TPB Ref.: A/YL-TYST/1334

Temporary Open Storage of Construction Machinery and Construction Materials, Recycling Materials and Used Electrical Appliances with Ancillary Workshop for a Period of 3 Years at Lots 366 RP (Part), 371 S.B (Part), 372 S.A, 372 S.B, 373, 374, 375 RP (Part), 376 (Part), 377 (Part), 378 (Part), 379, 380, 381 RP (Part), 458 (Part), 459, 460, 461, 462, 463, 464, 471, 472, 1323 (Part), 1324, 1325 (Part), 1337 (Part), 1338 (Part), 1339, 1340 (Part), 1341, 1342, 1344 (Part), 1345 (Part), 1346 (Part), 1349 (Part), 1350 (Part), 1351 (Part), 1353 (Part), 1354, 1355 (Part), 1356 S.A (Part), 1356 S.B, 1357, 1358 RP, 1359, 1360, 1361, 1362, 1363 RP, 1365 (Part), 1366 RP (Part) in D.D.119 & Adjoining Government Land, Yuen Long, N.T.

Our response to the comments of the CE/MN, DSD is found in the attachment.

DRAINAGE IMPACT ASSESSMENT

Drawing No:
P01

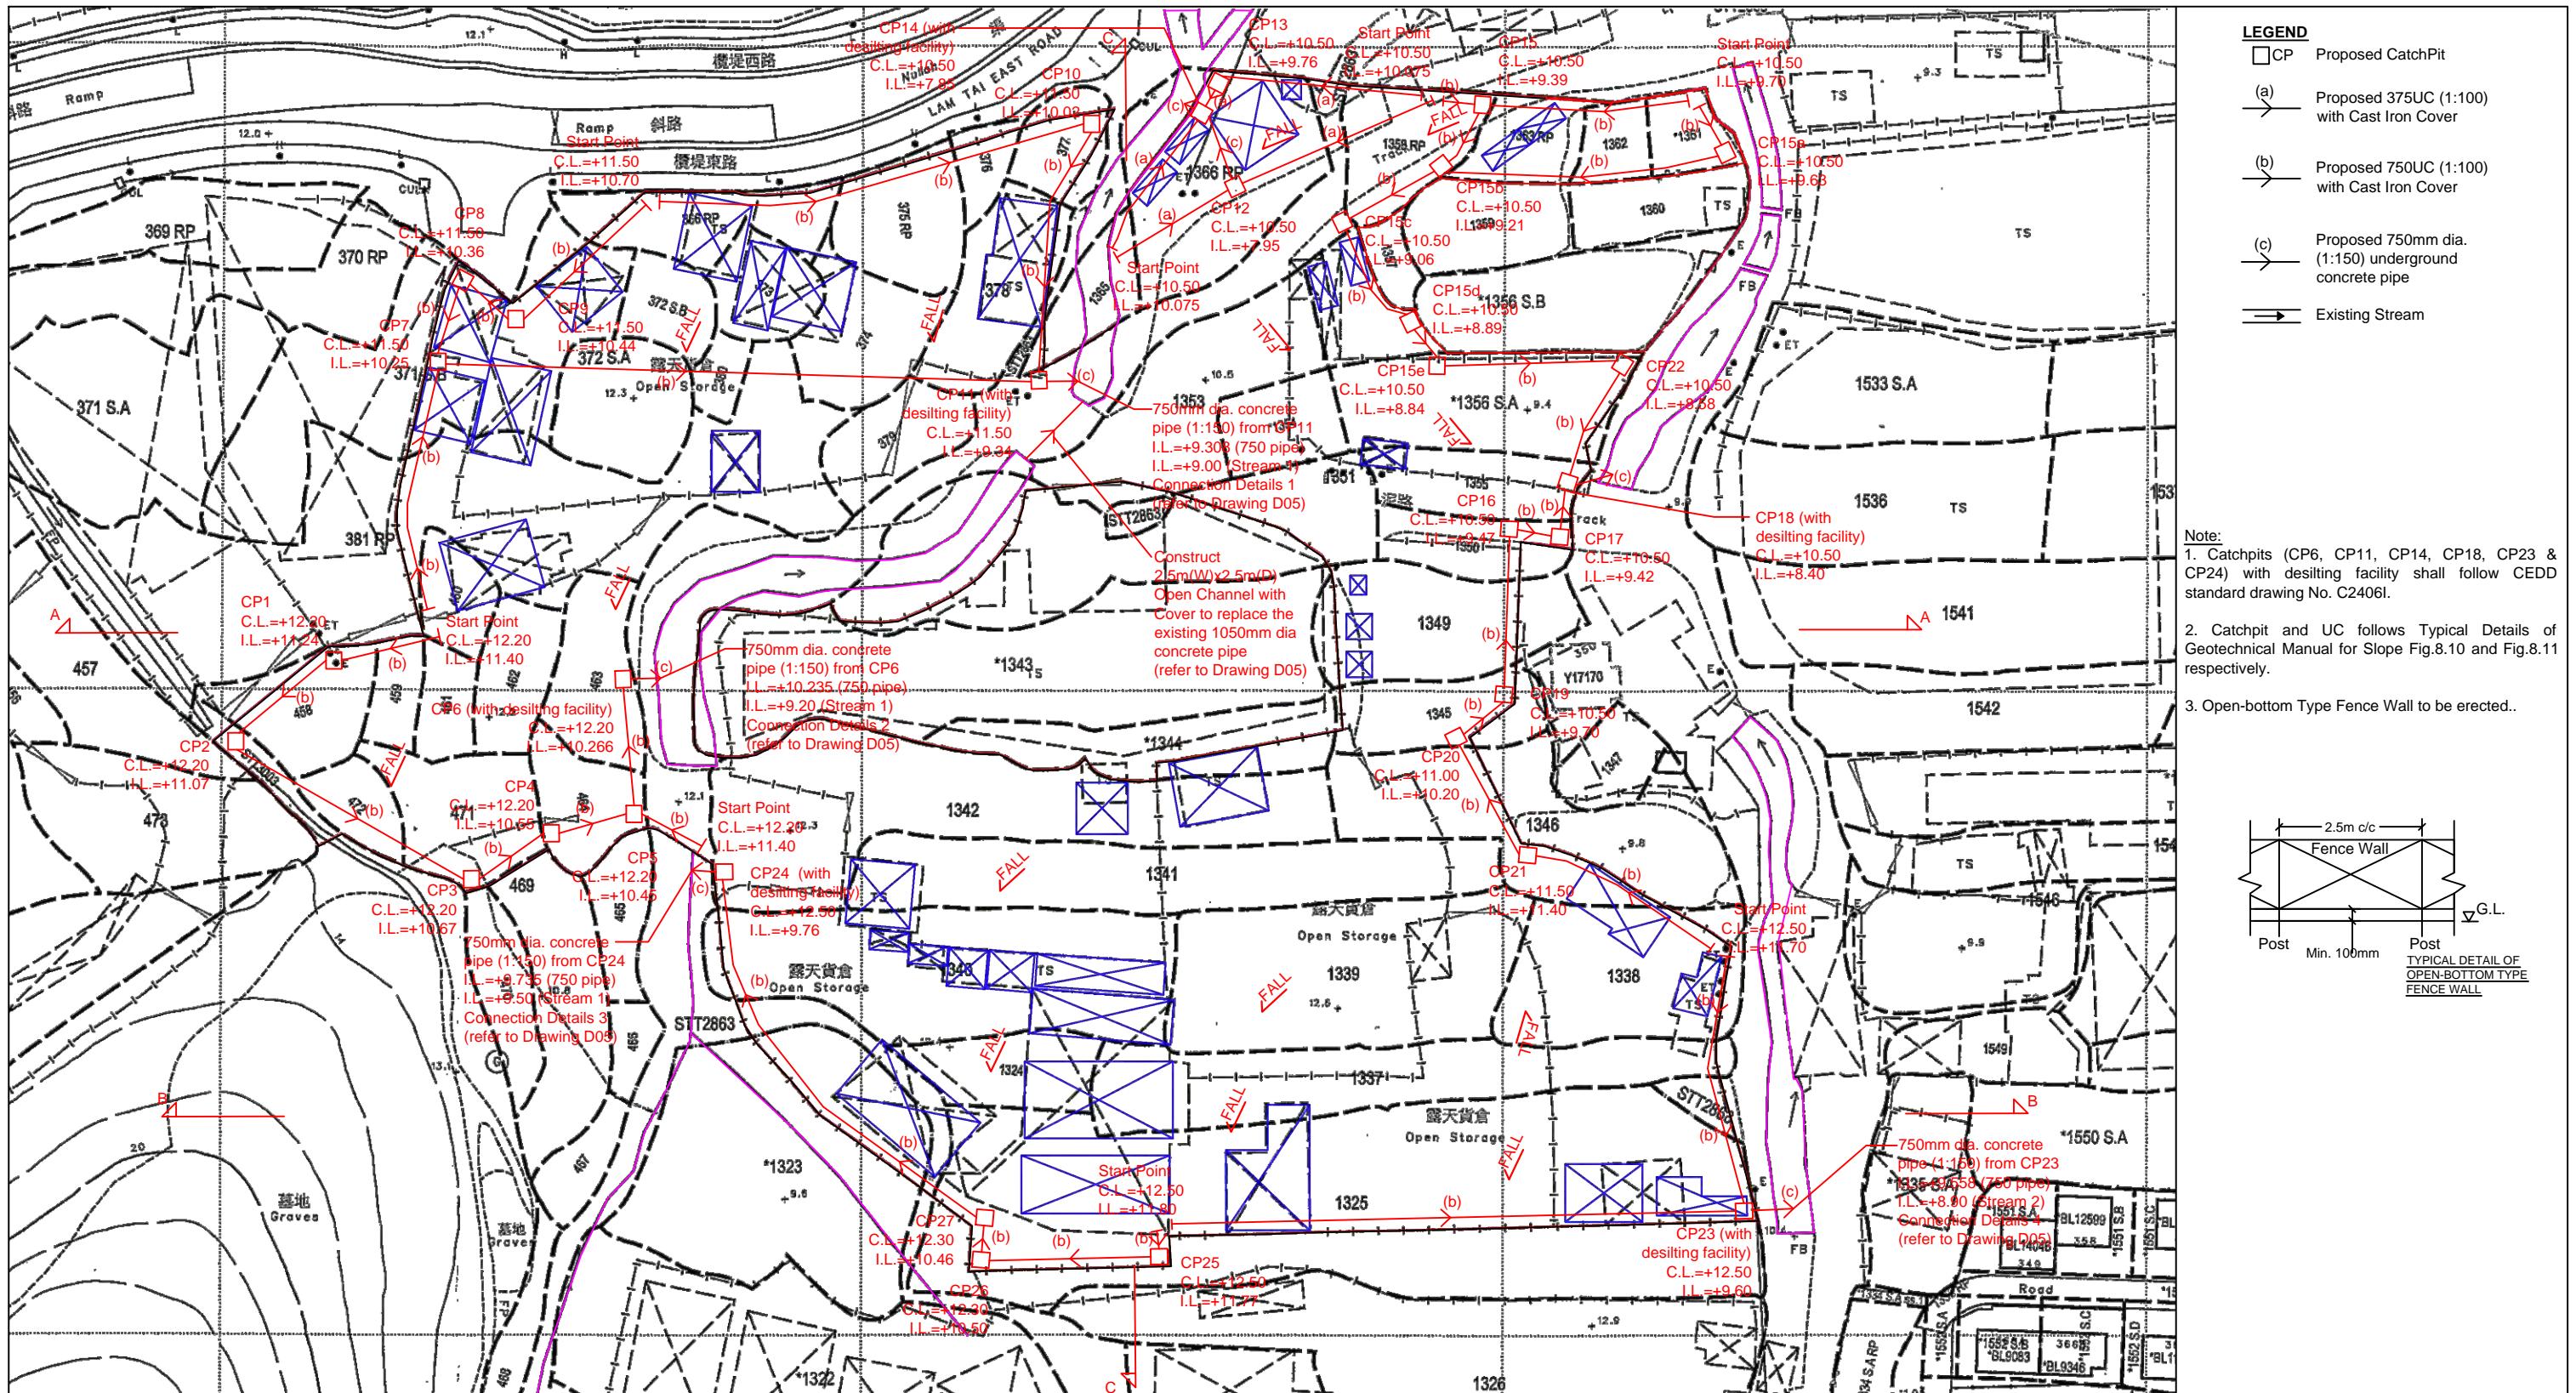
- Peripheral surface channels have yet to be provided along the site boundary of the lower sides to collect the surface runoff accrued on the application site and to intercept the overland flow from the adjacent lands (e.g. near Lot Nos. 1343, 1344, 1351 & 1358 RP), please review and/or clarify. This area has its own stormwater collection system and its level is higher than the application site, refer to photo 10-12.

- Please advise the levels of Stream 1 & 2, and advise whether the discharge will be affected by tidal level and backwater. The levels of Streams 1 & 2 is presented in Appendix C

Title:
Drainage Proposal - Details

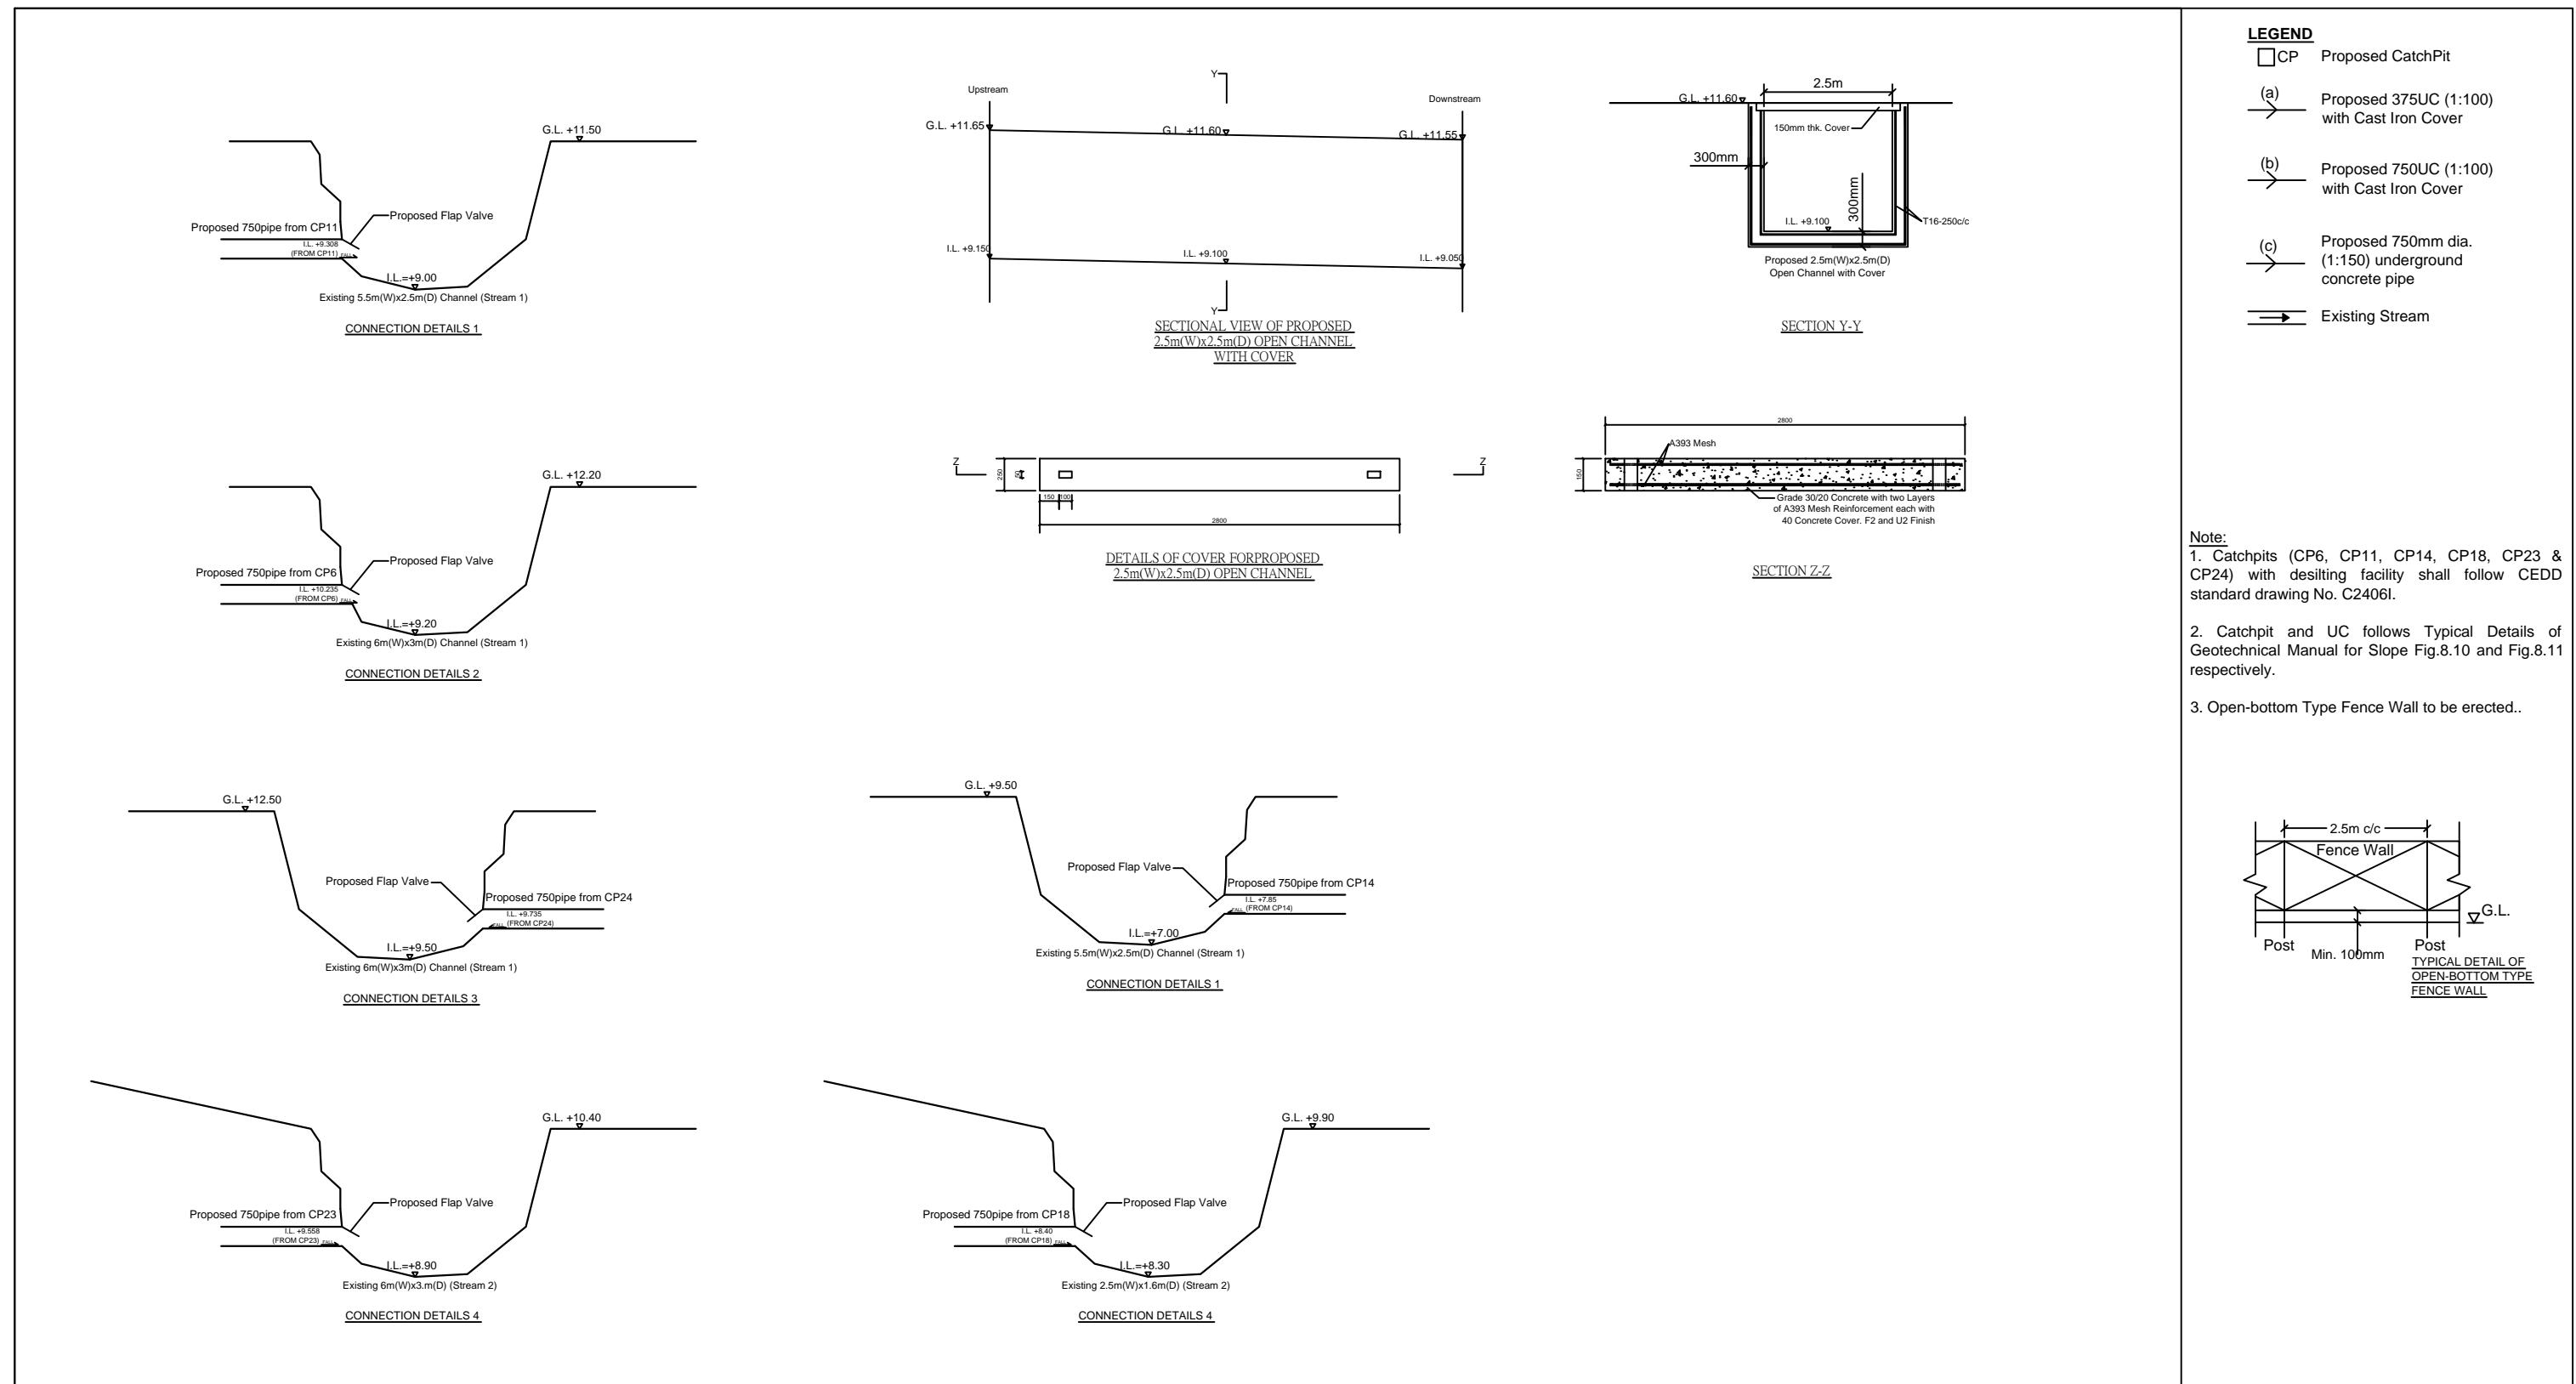
- Details of the proposed 750mm dia. concrete pipe at CP14 and CP18 to the existing stream are missing, please review and also update Drawing No. D05. These connection details are presented in Drawing D05

- Please review if the number of drawing title "Drainage Proposal - Details" should be D05.
- The hydraulic capacity of the critical section of

pipe at CP14 and CP18 to the existing stream are missing, please review and also update Drawing No. D05.

- Please review if the number of drawing title "Drainage Proposal - Details" should be D05. Typo, revised accordingly.
- The hydraulic capacity of the critical section of Stream 2 (i.e. 2.5m x 1.4m as indicated in Drawing No. P01) has yet to be checked in Appendix F, please review. It is provided.
